**Sent:** 16/04/2020 11:11:55 AM  
**Subject:** Objection Letter for DA2020/0302  
**Attachments:** Gale Objection Letter to DA2020 0302 16 April 2020.docx;

Re: Notice of Proposed Development NO: 2020/0302

41 Upper Clifford Avenue Fairlight.

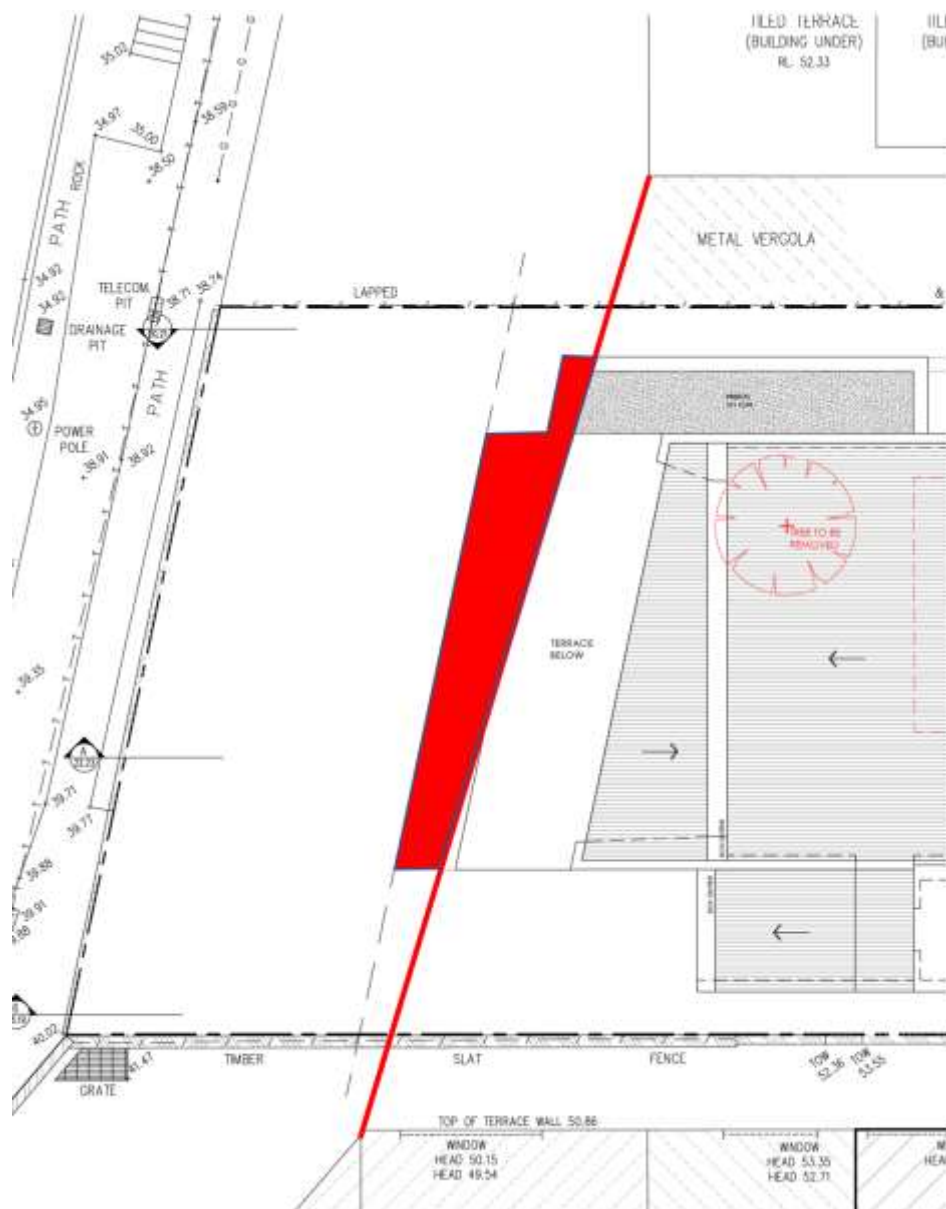
Privacy will be significantly compromised as occupants from unit 2 and unit 3 will be able to look directly into our bedroom and living areas facing south. This is particularly the case from the upper southern deck of unit 2 as depicted in the digital representation (05 and 06). The deck access on all levels of unit 2 and unit 3 will enable people to look back at the southern end of lower level of 43 Upper Clifford Avenue (bedrooms) and second level of 43 Upper Clifford Avenue (lounge and living areas). This would require us to have our blinds drawn at all times in our bedrooms and require installation of new blinds in our lounge area.

The privacy considerations fail to take into account the loss of privacy from the eastern facing large window and sliding doors on the second and third levels of 43 Upper Clifford Avenue.
